# HYUNDAI

## Technical Service Bulletin

GROUP HYBRID CONTROL	NUMBER 17-HC-004
DATE DECEMBER, 2017	MODEL SONATA PLUG IN HYBRID (LF PHEV)

**SUBJECT:** DTC P1BA7 PHEV BATTERY BMS AND WIRING REPLACEMENT

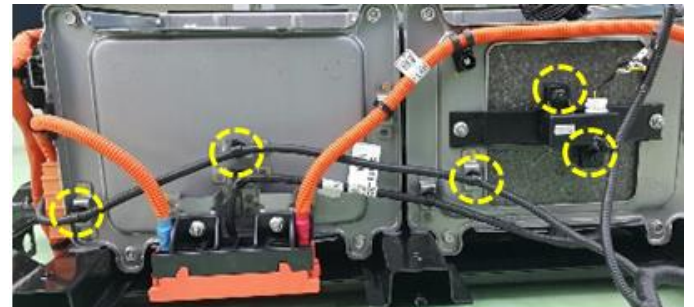
10. Remove the VPD mounting bolts and discard (NOTE: VPD will be discarded with the wiring).

12. Remove the mounting clips and remove the VPD mounting bolts.
13. Remove and discard the existing Sub-BMS Wiring including VPD and its 2 mounting bolts.

14. Install the new **SUB BMS WIRING P/N 37517-E6620**.

The new SUB BMS WIRING does not have a VPD, it is no longer needed.

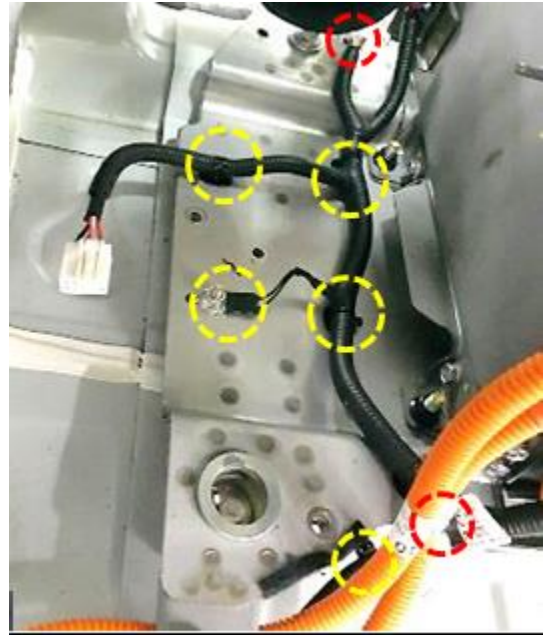
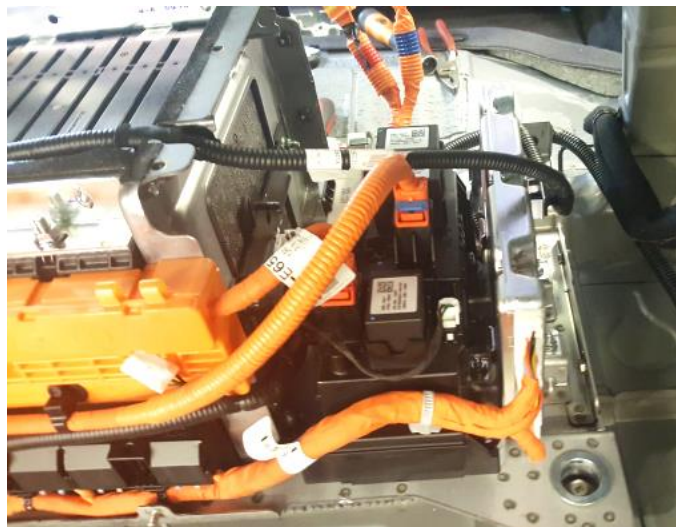
33. Remove the mounting clips, VPD nuts, and ground bolt.
34. Remove and discard the existing Main BMS Wiring, the VPD and its 2 mounting nuts.

The new MAIN BMS WIRING does not have a VPD. They are no longer needed.

35. Install the new **MAIN BMS WIRING P/N 37517-E6520**.
